Part Name: Crosstube Assembly, Mid Fwd

DART AEROSPACE LTD	Work Order:	
Description: Crosstube Assembly, Mid Fwd	Part Number:	D206-667-147
Inspection Dwg: D206-667-147 Rev: A		Page 1 of 2

DRAWING NO. D206-667-147	TITLE CROSSTUBE ASS'Y (206L MID FWD)	REV. A	DART AEROSPACE LTD ENGINEERING ORDER		D.E.O. NO. D206-667-147-A-1	SHEET NO. SHEET 1 OF 1	SCALE NTS
DRAWN <i>q</i>	CHECKED <i>ASS</i>	MFG. APPR. <i>AB</i>	APPROVED <i>MD</i>		DE APPR. <i>MD</i>		
DATE 11.07.15	DATE 11.07.20	DATE 11.07.21	DATE 11/07/21		DATE 11.07.21

DRAWING NO. D206-667-147	TITLE CROSSTUBE ASS'Y (206L MID FWD)	REV. A	DART AEROSPACE LTD ENGINEERING ORDER	D.E.O. NO. D206-667-147-A-2	SHEET NO. SHEET 1 OF 1	SCALE NTS
DRAWN AJS	CHECKED	MFG. APPR.	APPROVED	DE APPR.		
DATE 12.08.02	DATE 12.08.02	DATE 12.08.02	DATE 12.08.02	DATE 12.08.02	DATE 12.08.02

DETAIL P
BONDING STRAP INSTALLATION 2 PL

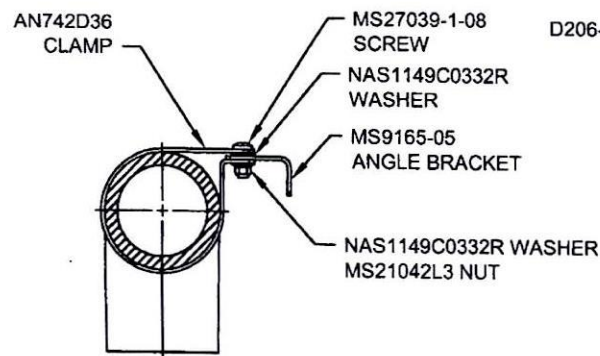
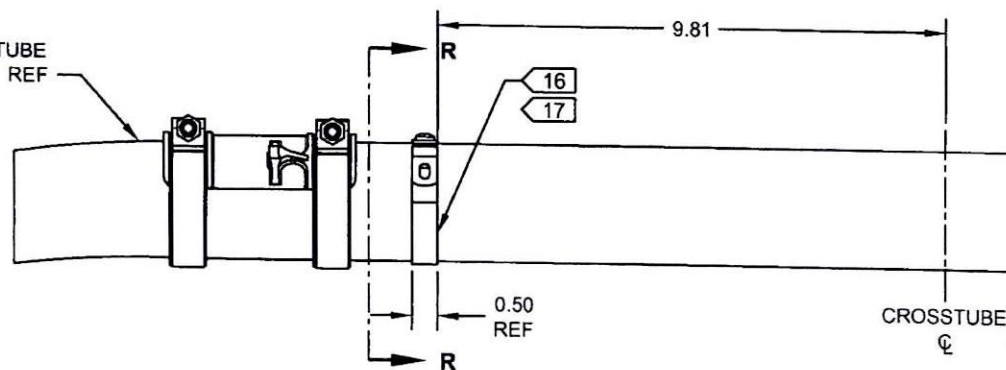
PURPOSE:

ADD ELECTRICAL GROUNDING STRAP

ITEM	QTY -147	PART NUMBER	DESCRIPTION	
1	X	D206-667-147	CROSSTUBE ASSEMBLY (206L MID FWD)	
10	2	AN742D36	CLAMP	] ADD
11	2	MS9165-05	ANGLE BRACKET	
12	2	MS21042L3	NUT (OR MS21042-3)	
13	2	MS27039-1-08	SCREW	
14	4	NAS1149C0332R	WASHER (OR AN960C10L)

- 16) MASK AREA UNDER CLAMP PRIOR TO PAINTING
- 17) SEAL EDGES WHERE AN742D36 CLAMP MEETS WITH THE CROSSTUBE USING SIKAFLEX-241/-291 OR MIL-S-8802 CLASS B2 OR PROSEAL 890 SEALANT
- 18) PERFORM RESISTANCE CHECK TO ENSURE MAX RESISTANCE IS 10 MILLIOHMS
